CALL NO. 100
CONTRACT ID NO. 241306
ADDENDUM # 1

Subject: Breathitt County, NHPP 0151 (090)
Letting March 21, 2024

- (1) Added - Traffic Management Plan - Pages 583A-583L of 649
- (2) Revised - Plan Sheets U-039, U-041, U-042, U-044, U-045, U-047

Sheet No.	U-039
City of Jackson - Utility Relocation	BREATHITT COUNTY, KY - KY15, ITEM NO. 376.00
Date	2023-08-17
Drawn By	JCM
Scale	AS SHOWN
Job No.	933.40

CITY OF JACKSON
 UTILITY RELOCATION
 BREATHITT COUNTY, KY - KY15
 ITEM NO. 10-376.00
 COURT STREET LIFT STATION DETAILS

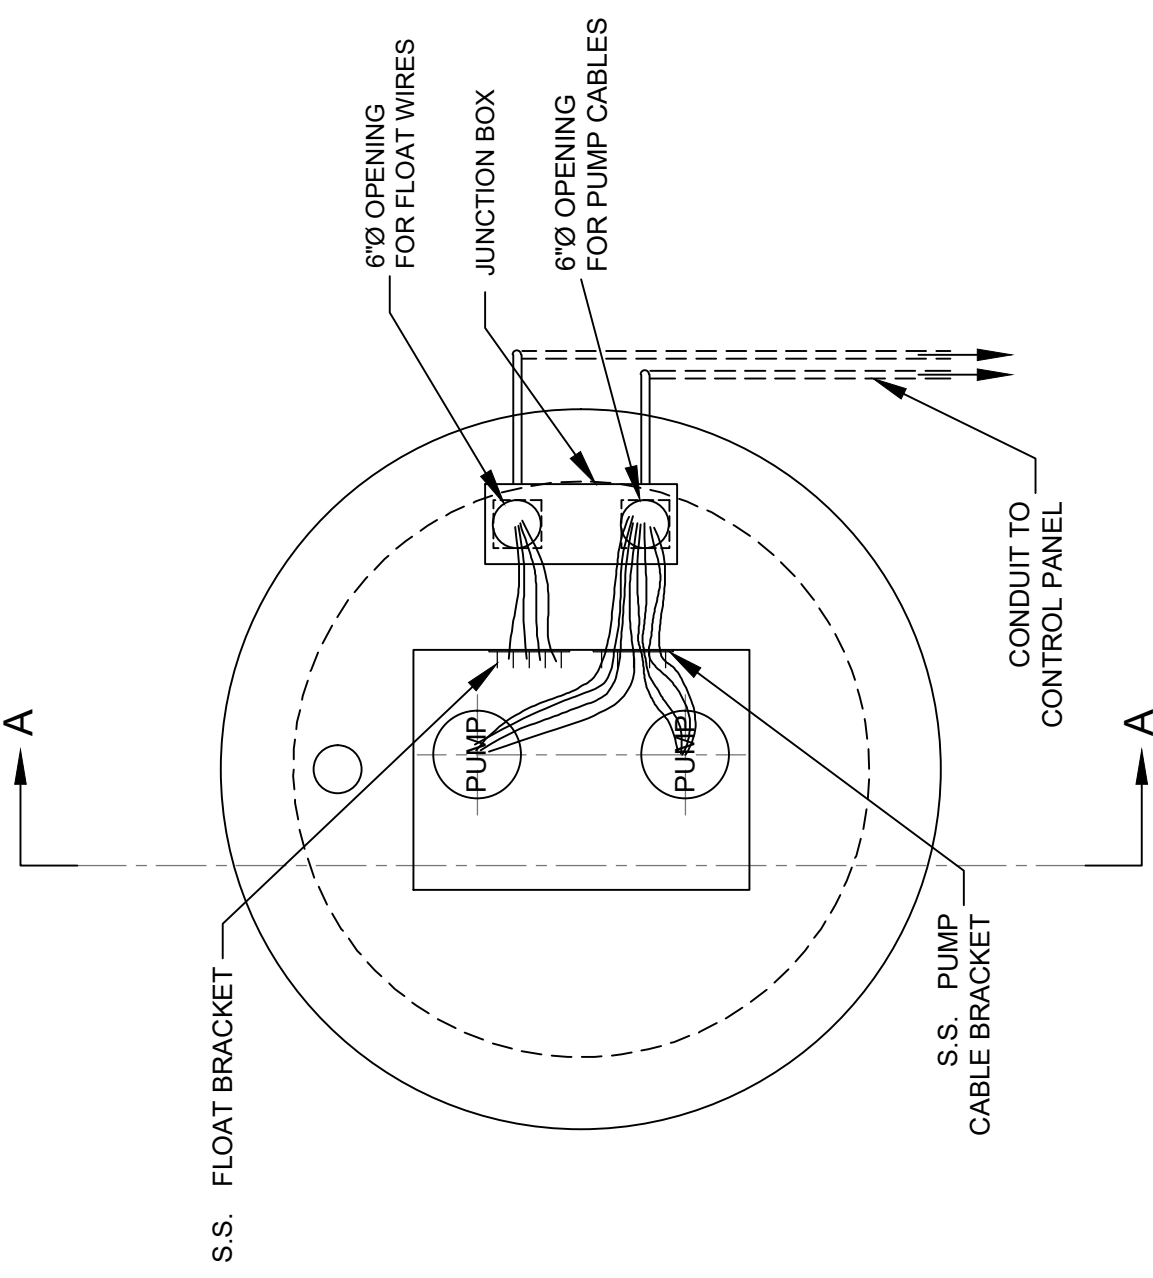
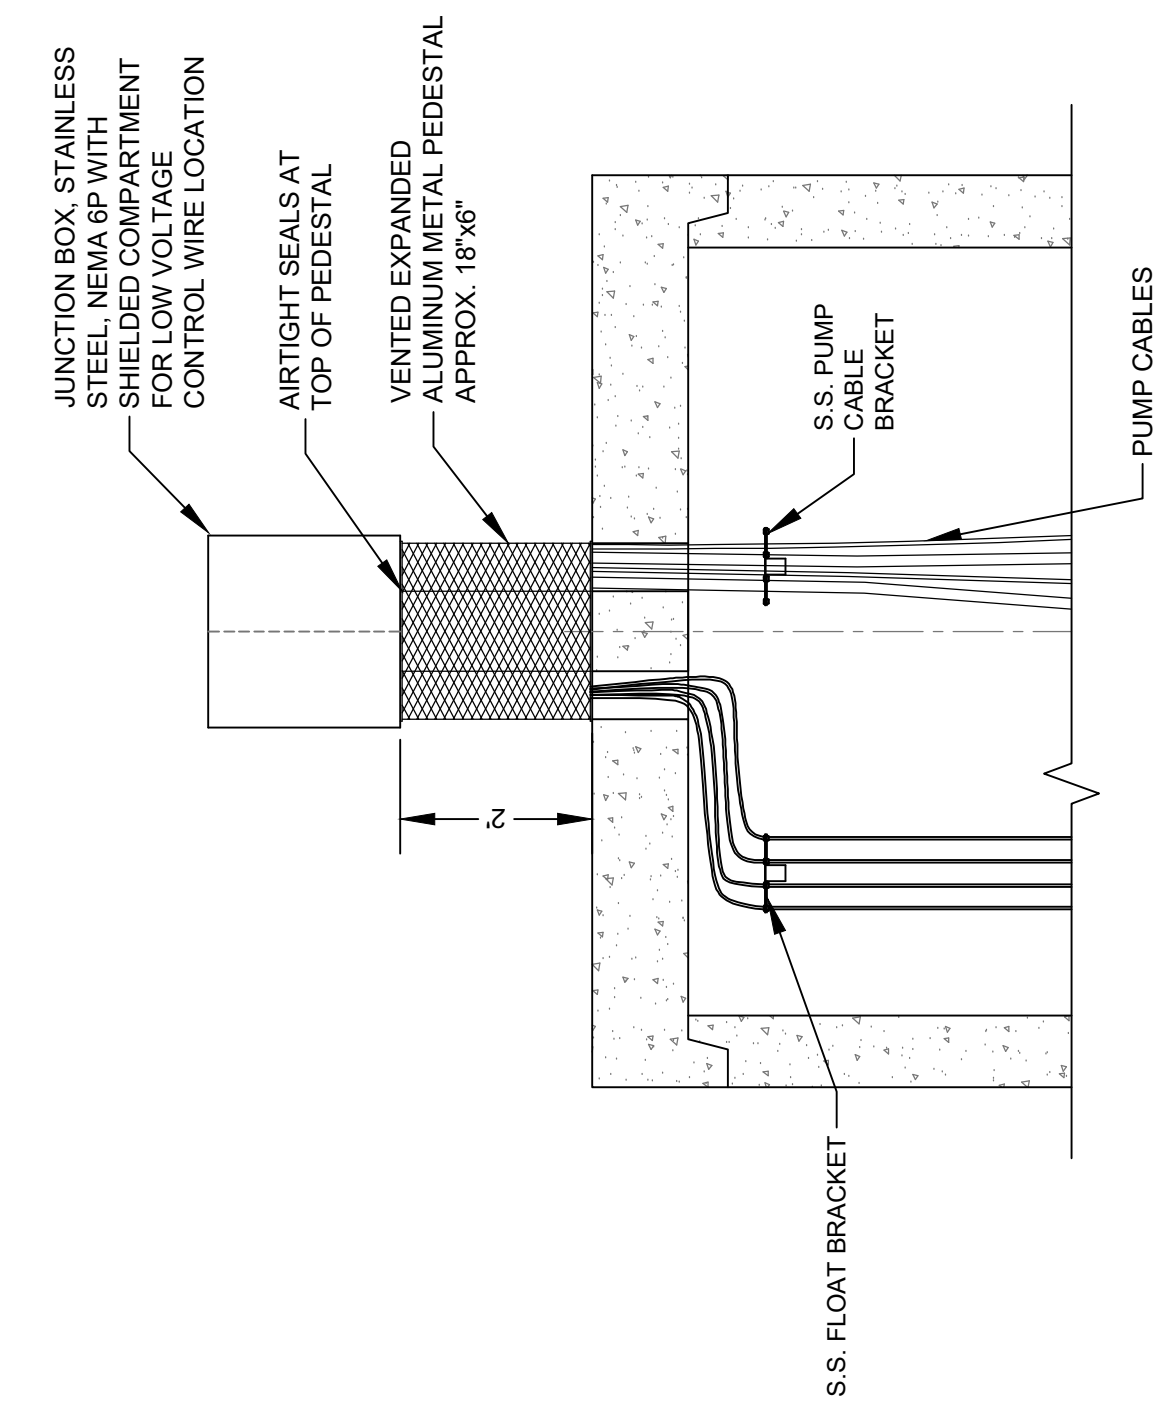
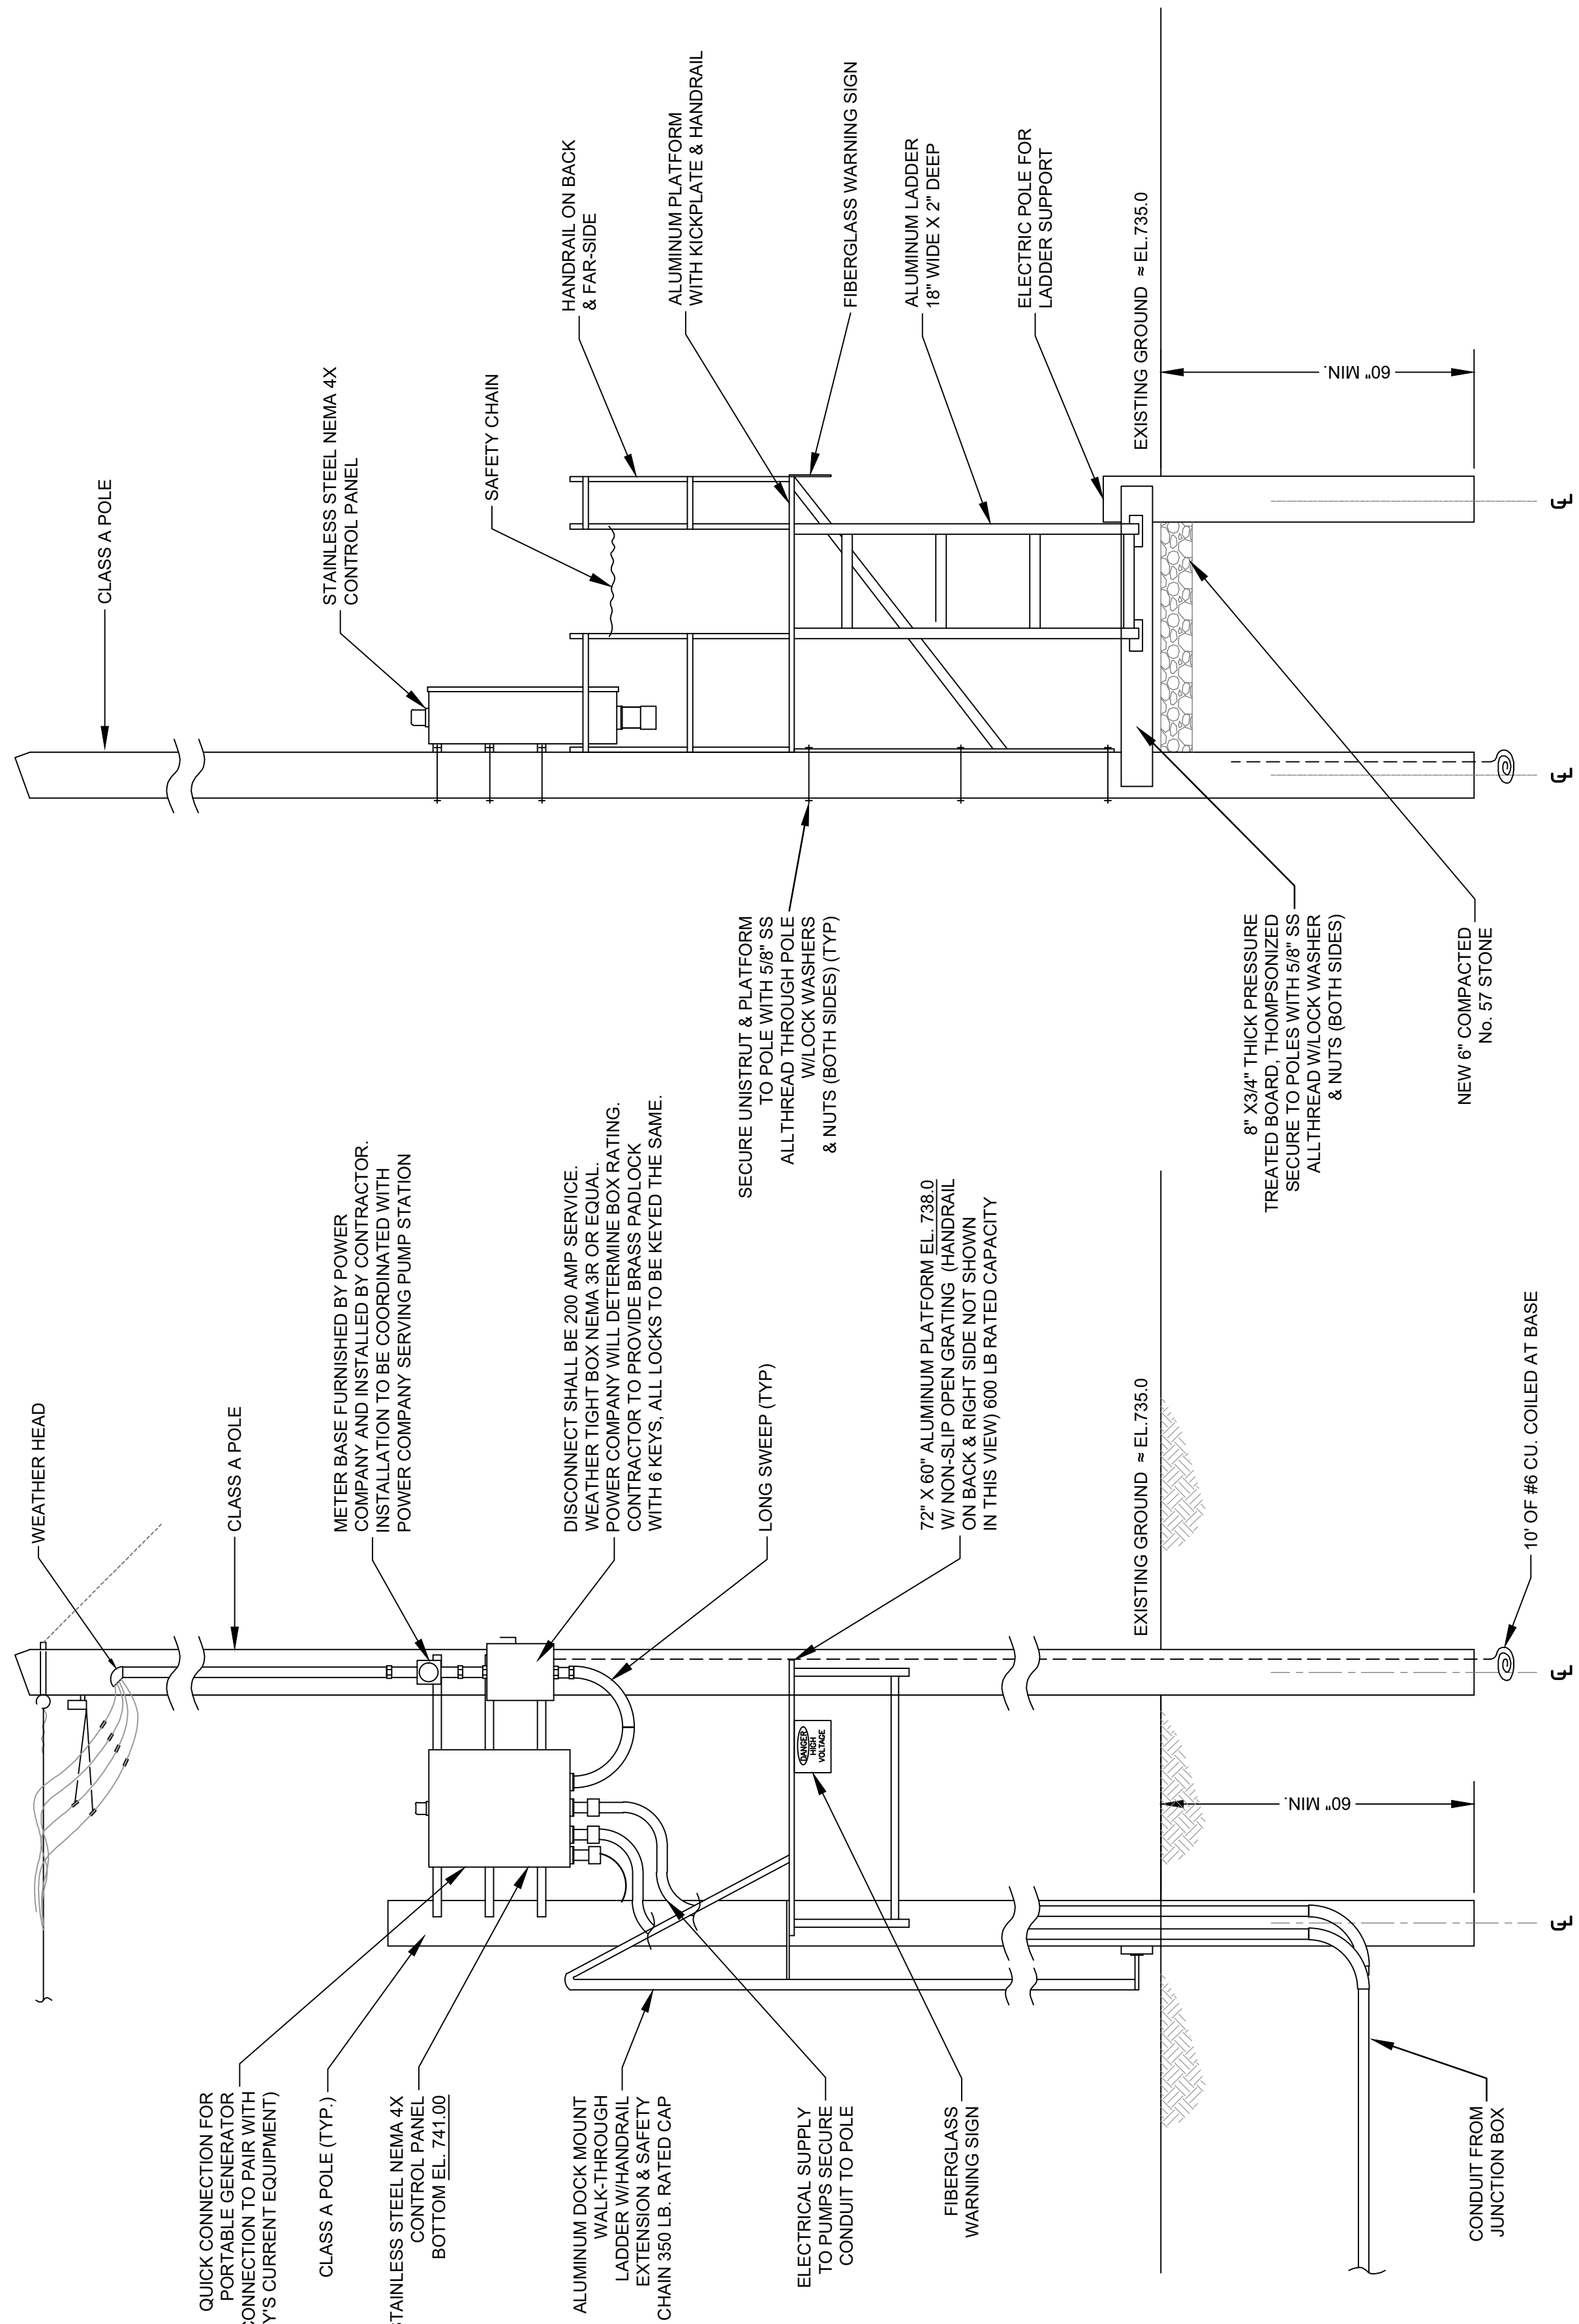
2024-02-20 ADD1 CHANGE JUNCTION BOX TO 6P
 REVISIONS
